ENDL TEXAS

Date: 19 July 2008
 To: SNIA OSD TWG and T10 Technical Committee
 From: Ralph O. Weber
 Subject: OSD-2 CDB Continuations Definition and Usage

Figure 4 — OSD security model transactions

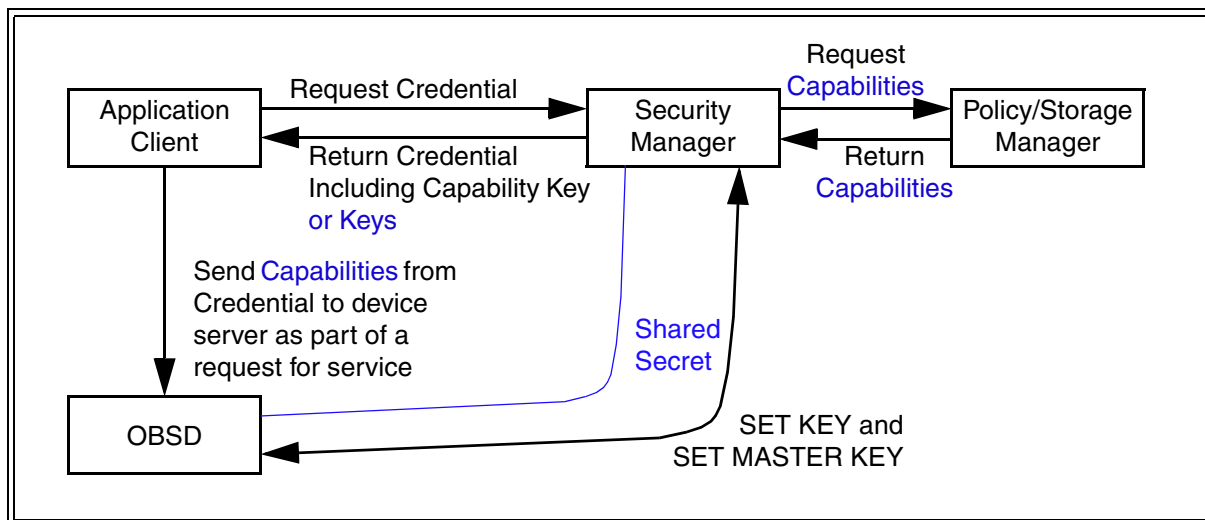
{{With the exception of 'Shared Secret', all the blue text in figure 4 is a replacement for existing text. To keep figure 4 manageable, strikeouts are not show for the old text.}}
